S A V A N N A H H I S T O R I C D I S T R I C T
B O A R D O F R E V I E W

REQUEST FOR CERTIFICATE OF APPROPRIATENESS

MPC File No.: 26-000064-COA

Address: 301 East Huntingdon Street

1. Non-conforming front facade window that is mostly obscured by front stairway

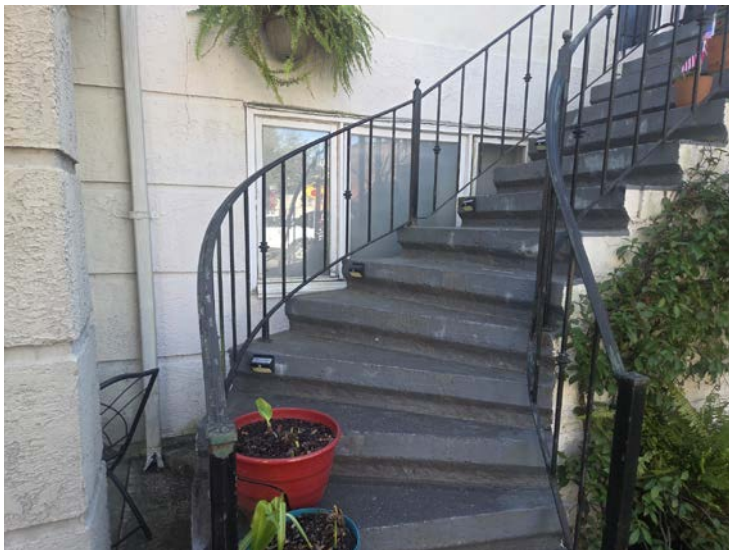
All of the windows fit this standard except for one bottom-floor window that is partially obscured by the staircase. This non-conforming window is already a part of the façade, and has presumably been there since the building was built in the 1980's. Therefore, staff finds it acceptable for this window to be replaced in-kind.
